BULLETIN NO.: E-399

ROM Updated

BULLETIN NO.: E-400

ROM Update

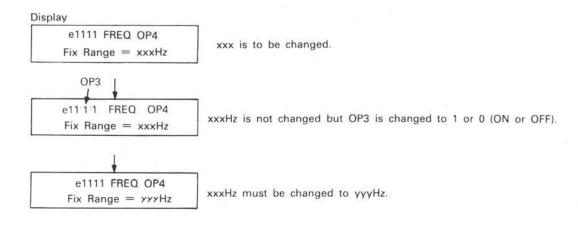
1) OP2, 3, and 4 fix ranges cannot be edited correctly with MIDI parameter change data.

Wrong (TX81Z response)

OP3 fix range Received as OP2 operator ON/OFF

MIDI exclusive data "Parameter change" (When OP4 fix range is changed)

Power Transformer Modified

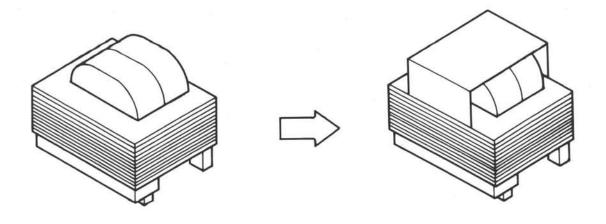
A metal cover has been added to the transformer to prevent vibration due to leak magnetic flux.
